State of California – Natural Resources Agency  
DEPARTMENT OF FISH AND WILDLIFE  
Inland Deserts Region  
3602 Inland Empire Boulevard, Suite C-220  
Ontario, CA 91764  
[www.wildlife.ca.gov](http://www.wildlife.ca.gov)

October 10, 2024  
*Sent via email*

**Comments on the Notice of Determination for an Addendum to the 1991 Environmental Impact Report: Water from the Owens Valley to Supply the Second Los Angeles Aqueduct 1970 to 1990, 1990 Onward, Pursuant to a Long-Term Groundwater Management Plan for Replacement of Wells W247 and W379 (Project), SCH# 1989080705, and Notice of Exemption**

Exhibit 7A

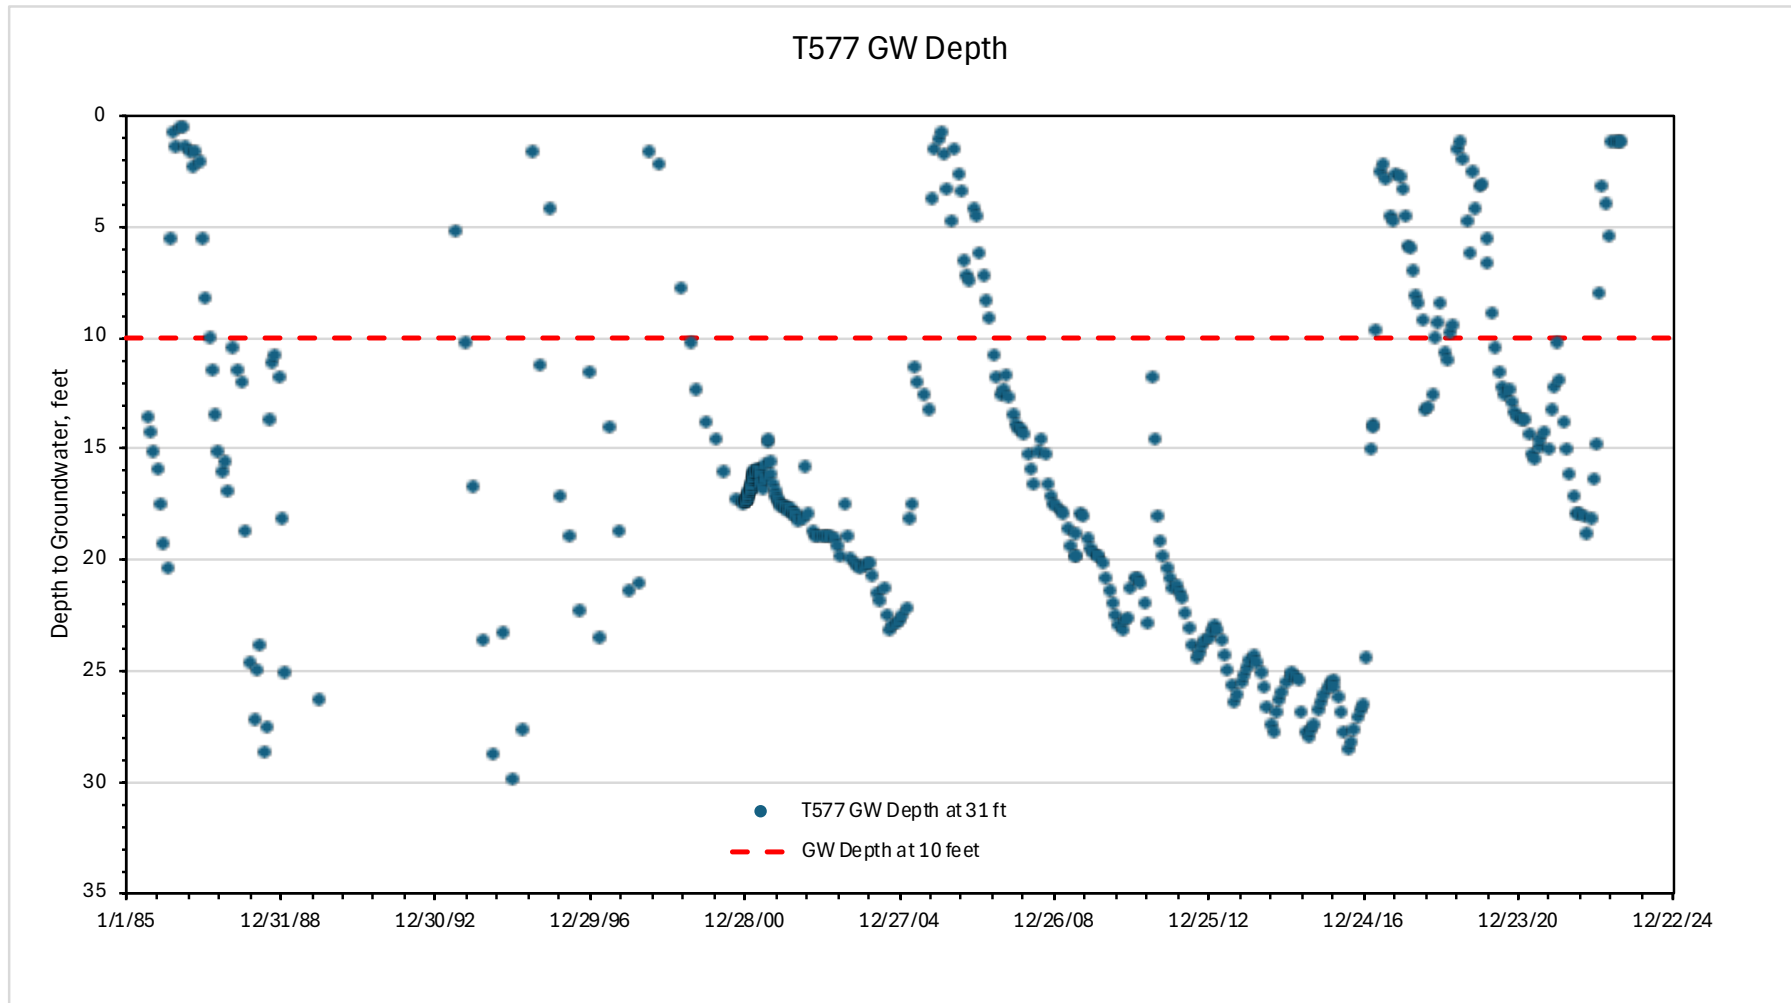
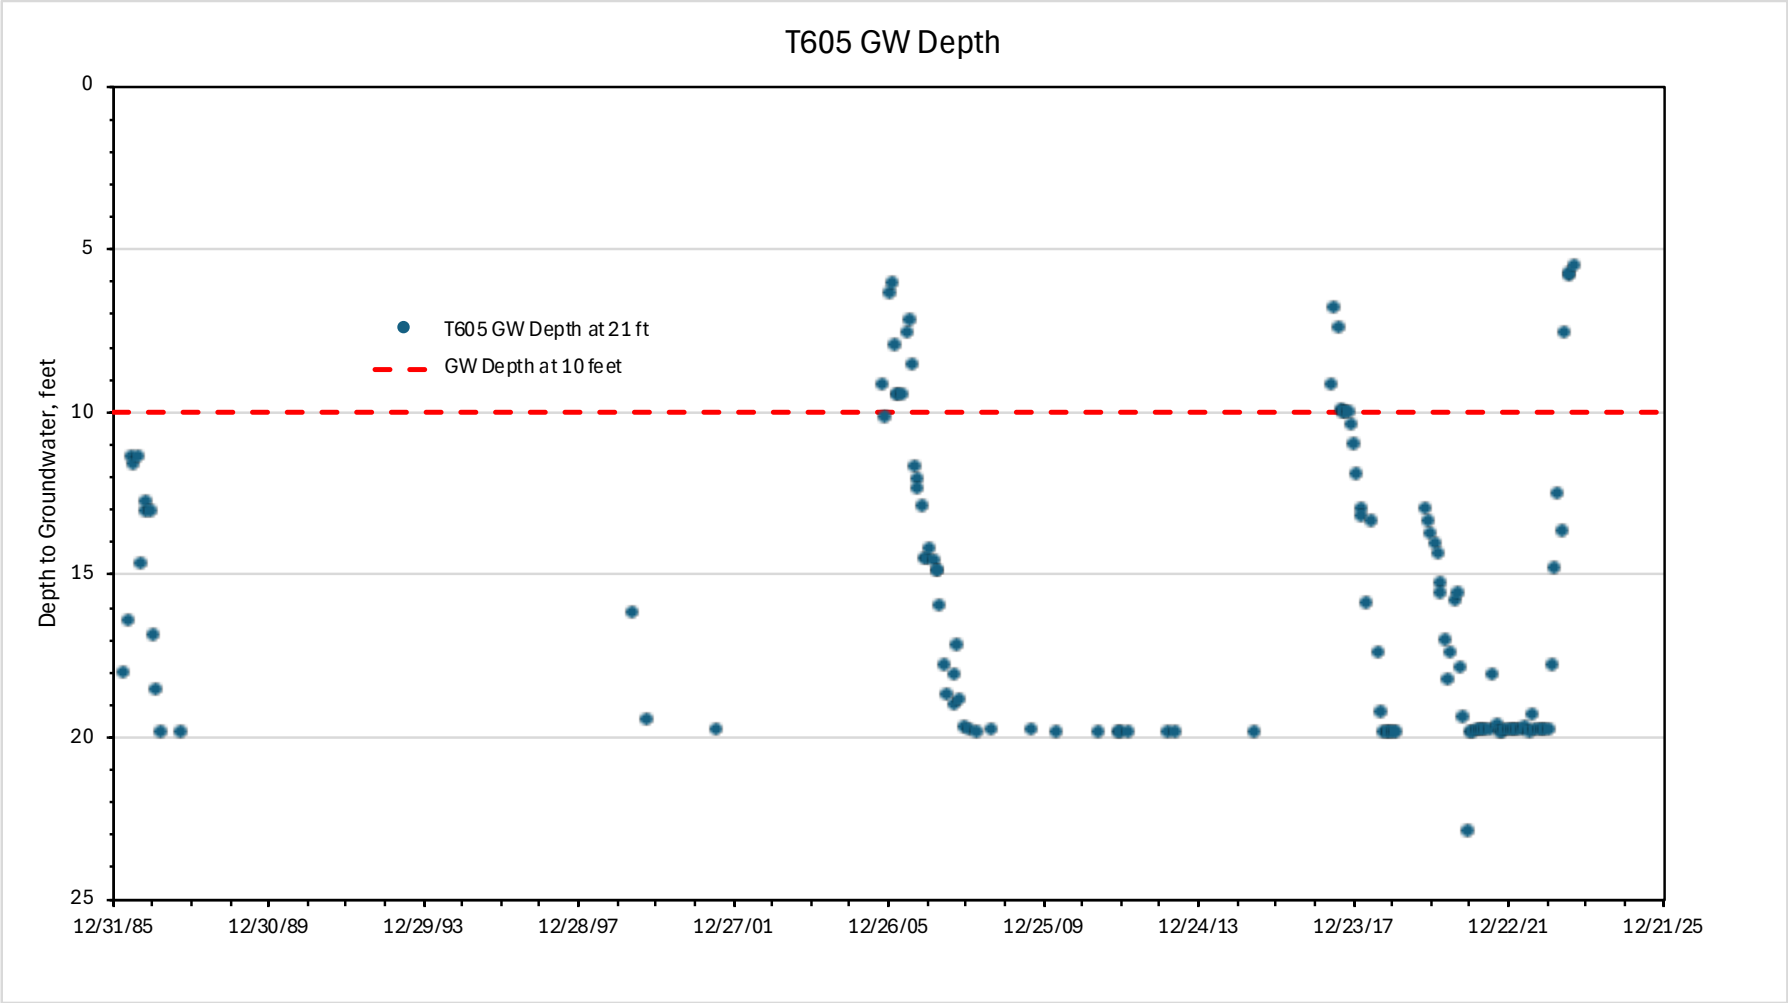
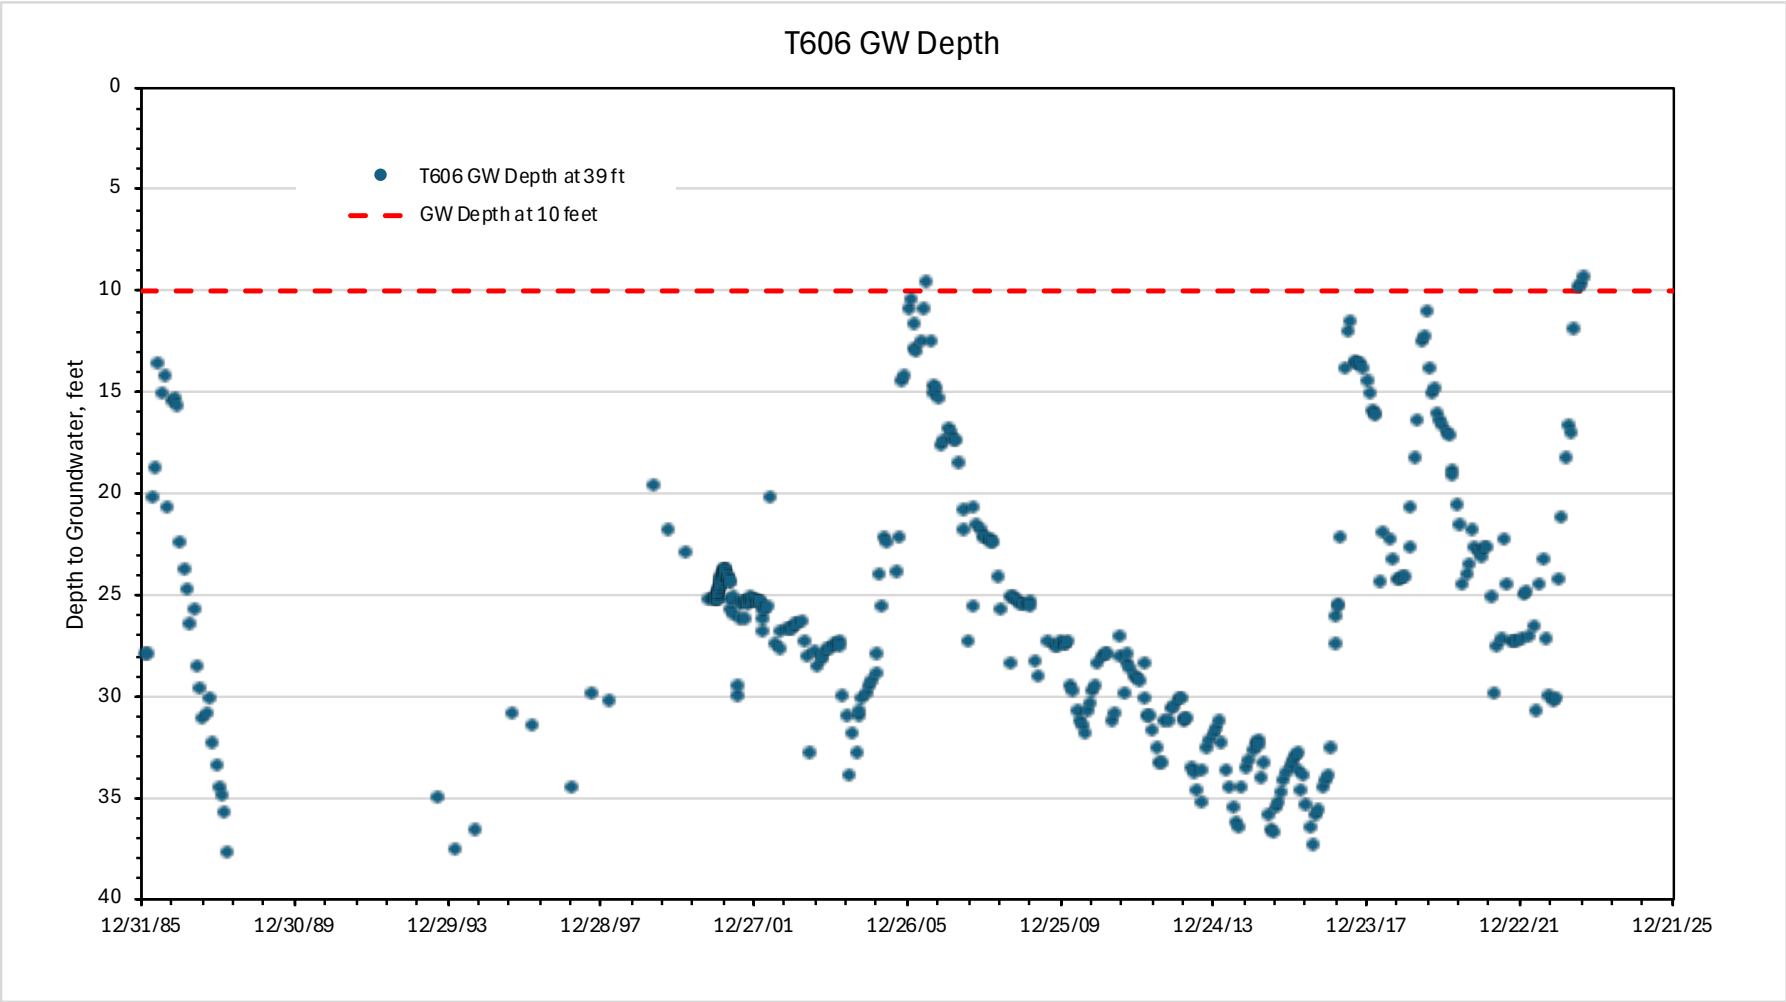
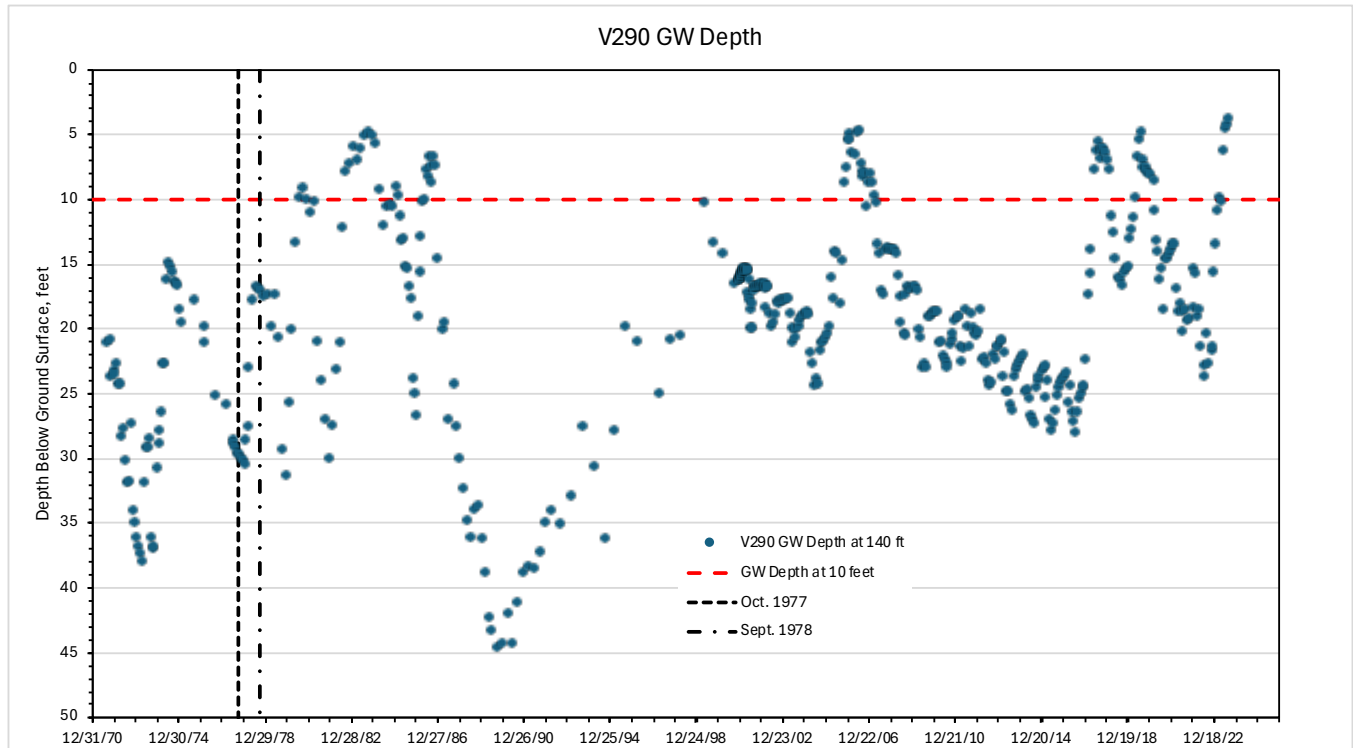
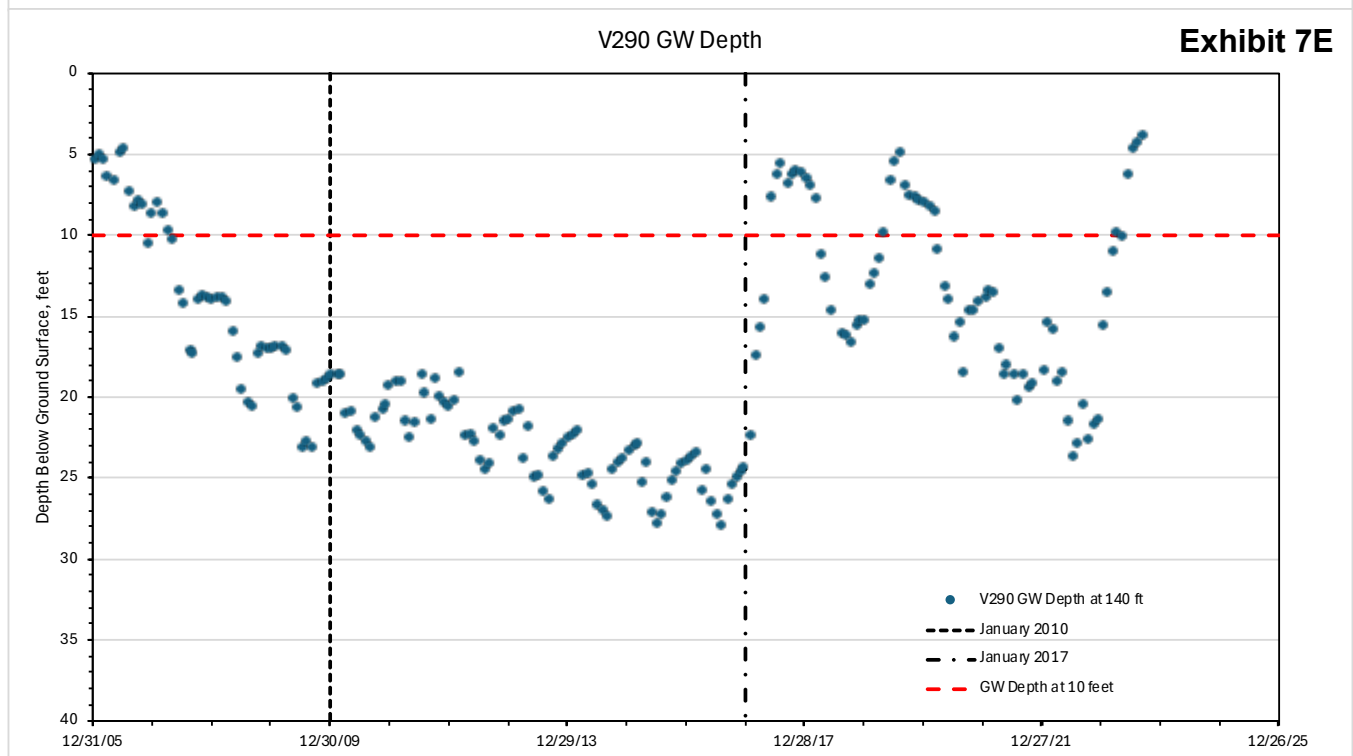
Hydrographs of historical shallow groundwater levels in the wells surrounding the proposed well W247R show levels vary significantly; see Exhibit 3A for locations. Exhibits 7A through 7F are hydrographs of the wells surrounding existing well W247. These hydrographs show that the depth of groundwater has fluctuated significantly in the Laws Wellfield area around well W247. At monitoring well T606, a shallow well 50 feet northeast of proposed well W247R (Exhibit 7C and 9A), the depth to groundwater changes from 10 feet to 37 feet in a recent 10-year period from 2006 through 2016 (Exhibit 7A). A similar decline occurred in a well T577, 1,800 feet to the southeast, from near zero to 28 feet deep (Exhibit 7C). A third shallow well, T605, varies from a depth of 5 to greater than 20 feet, which is the maximum depth of the well.

Well V290 has been monitored since 1971, which provides the longest record of shallow groundwater levels in the vicinity of W247R (Exhibits 7D and 7E). The V290 hydrograph shows multiple periods of groundwater decline, including the decline experienced in the dry year 1977-78. The recent 2010-2016 maximum depth of groundwater at well V290 was like the dry year 1977-78 maximum. This suggests that the conditions during the 2010 through 2016 period at well W247 could be used instead of the 1977-78 period in the worst-case groundwater modeling simulation with the drawdown from pumping new well W247R being added to the regional decline in groundwater elevations when no pumping was occurring in the adjacent wells.

CDFW recommends that LADWP conduct the groundwater model simulations for new wells W247R and W379R to estimate changes in shallow and deep groundwater levels using the worst-case three hydrological water years as the Agreement requires. CDFW also recommends resolving data gaps in the hydrogeologic setting at the Laws and Big Pines Wellfields before the worst-case modeling is done. Reporting of the modeling analyses of potential impacts from pumping these deep wells should include documenting when and where the new well drawdowns will change the actual seasonal groundwater elevations and depths below the ground surface, not just the difference in relative drawdowns. Furthermore, to support a conclusion that the new wells will not result in any new significant impacts, the analysis of impacts would need to demonstrate that: 1) pumping these new deeper wells will not result in groundwater levels below 10 feet bgs any longer than the current non-drought condition; 2) the increased drawdown in the deep aquifer systems will not interfere with pumping in adjacent wells; 3) any changes in the magnitude and/or direction of the vertical gradient between the shallow and deep aquifers will not result in additional shallow groundwater storage losses, declines in groundwater levels that harm overlying vegetation and habitats, or changes in groundwater quality in either the shallow or deep aquifers; and 4) the increased deep aquifer pumping will not result in increased loss of groundwater storage or surface water flow in the recharge source areas. Finally, CDFW recommends conducting this analysis of impacts for well W247R to inform whether the increase in deep aquifer pumping results in an impact on groundwater levels to the north in the Chalfant Valley, to the west at Five Bridges near wells W385R and W386R, or northwest at Fish Slough.

**Exhibit 7F**

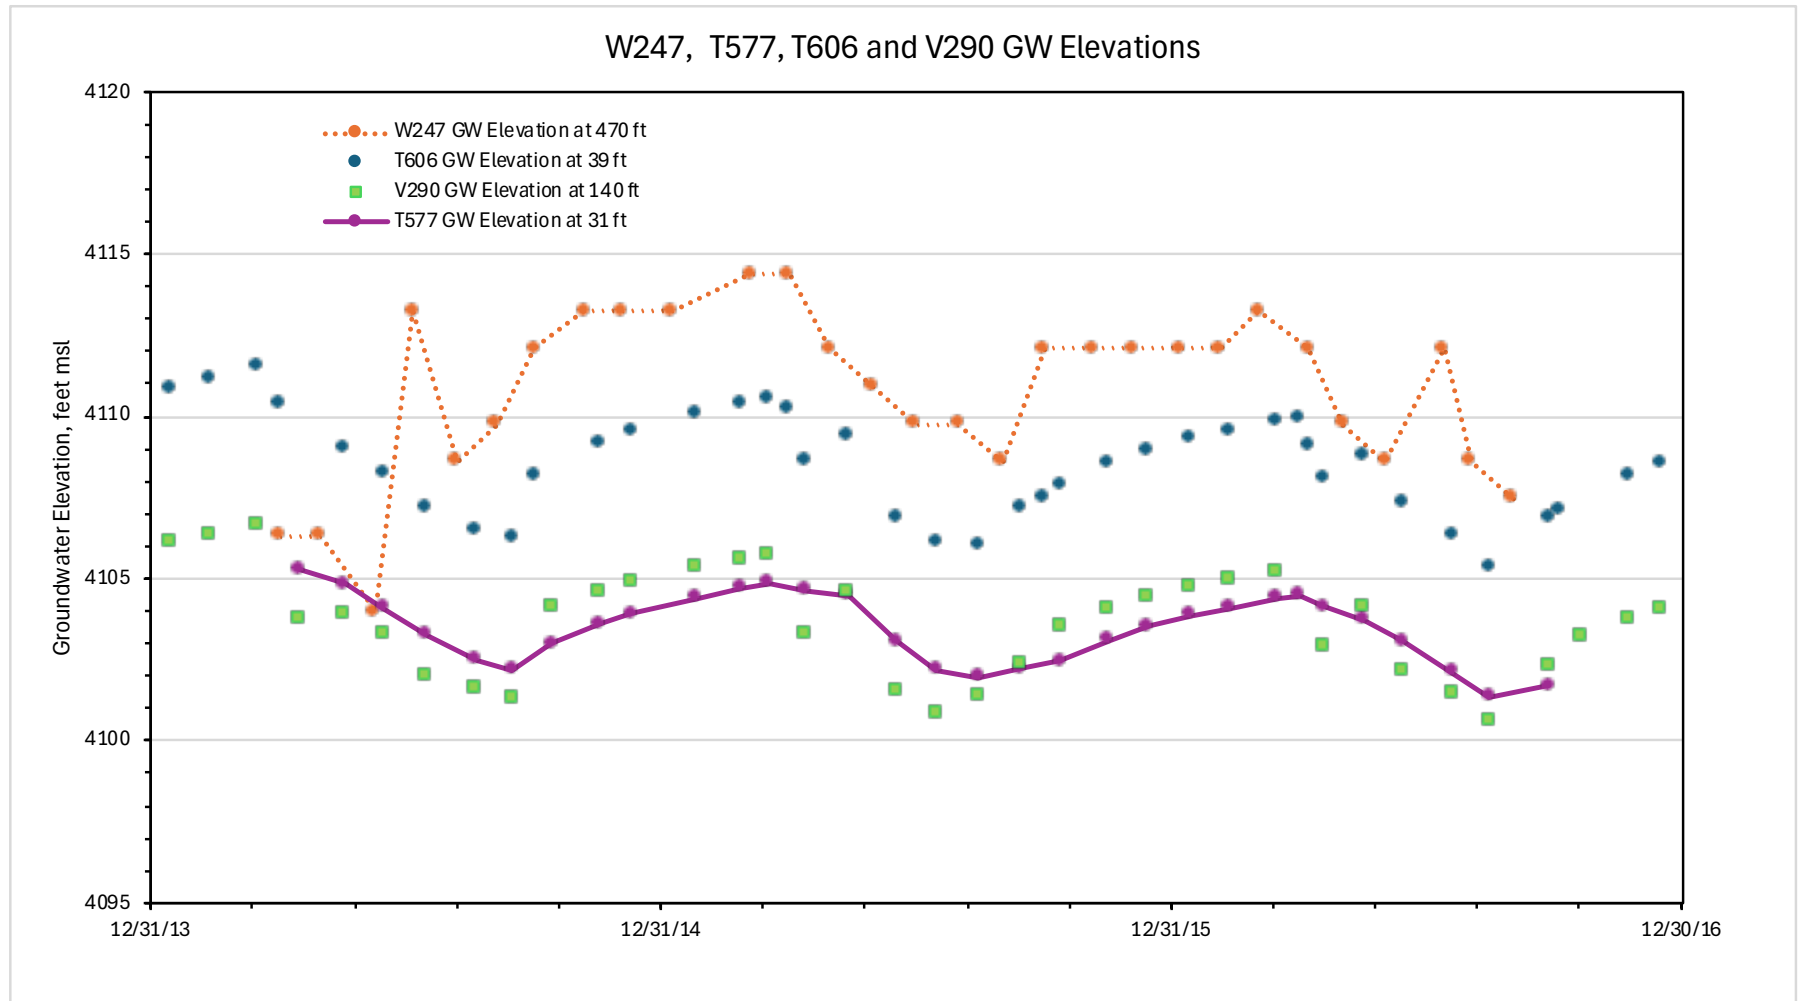
Exhibit 7F is a hydrograph of the recorded groundwater elevations at well W247 during the no-pumping period of 2014 through 2016, along with the elevations of the nearest monitoring wells, T577 and T606, Figure 7A-7B. This hydrograph shows that during this period of no pumping, the groundwater elevation in well W247, which is screened from 28 to 470 feet below the ground surface (bgs), is higher than the groundwater levels in the surrounding shallower wells, which are screened from 31 to 140 feet bgs. This suggests that the deeper groundwater naturally flows upward during periods of no pumping, i.e., a natural upward vertical gradient. This upward vertical gradient was also found between the shallow and deep aquifer systems to the west in the area of Fish Slough. For example, the recently constructed sets of monitoring wells, T978S and T978D, and FS#3S and FS#3D, in the southern portion of Fish Slough, have a natural upward vertical gradient, Exhibits 13A and 13B. The worst-case modeling of the pumping impacts at the new well W247R should analyze the changes in upward vertical during pumping because this upward flow is a source of recharge to the shallow aquifer system. Reducing or reversing the rate of vertical groundwater flow can have a widespread impact on shallow groundwater levels and overlying vegetation and may impact groundwater quality.
